City of Marysville
 Development Services
 80 Columbia Avenue
 Marysville, WA 98270

Response to Comments

Project Name: English Crossing Townhomes
 Project File Number: PA23-012- Technical Review 1
 Review Completion: June 19, 2023

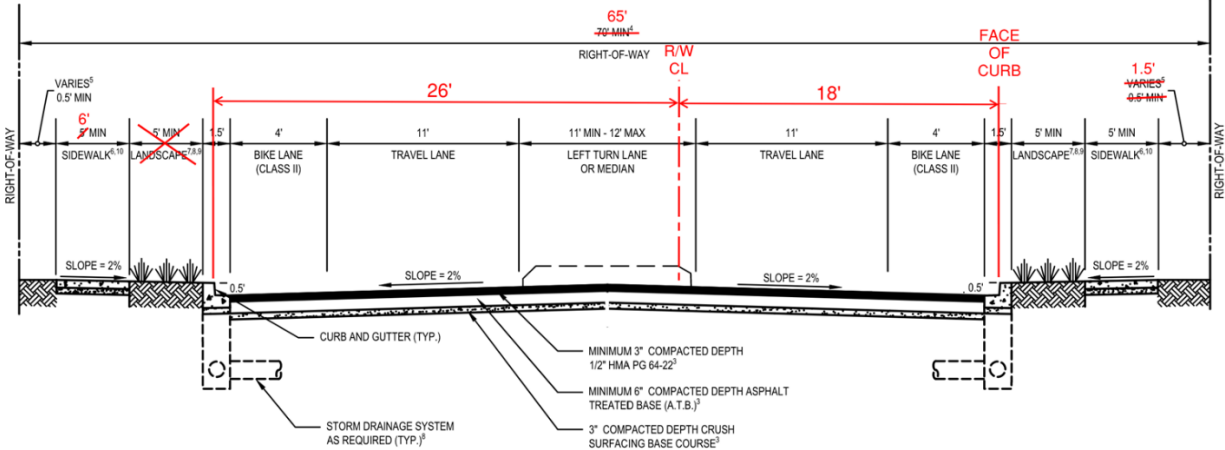
<p>Civil Plan Review: Reviewer: Shane Whitney, Civil Plan Review</p>	
<p>1. <u>Existing utilities:</u></p> <p>a. Sanitary sewer: None that is available to connect to at this time. The project will need to connect to the future trunk line being extended up from 156th.</p> <p>b. Water: There is an existing 12 inch main within 172nd and an 8 inch within 19th that I don't have record drawings for at this time.</p>	<p>Sewer going Construction from 156th has started with plans from 3 projects to bring the sewer to just south of Ziplly Fiber Station. This project will likely have to extend to 172nd and up 19th.</p> <p>Waterline has been located and Fire Flows in Lodge Apartments have been obtained.</p>
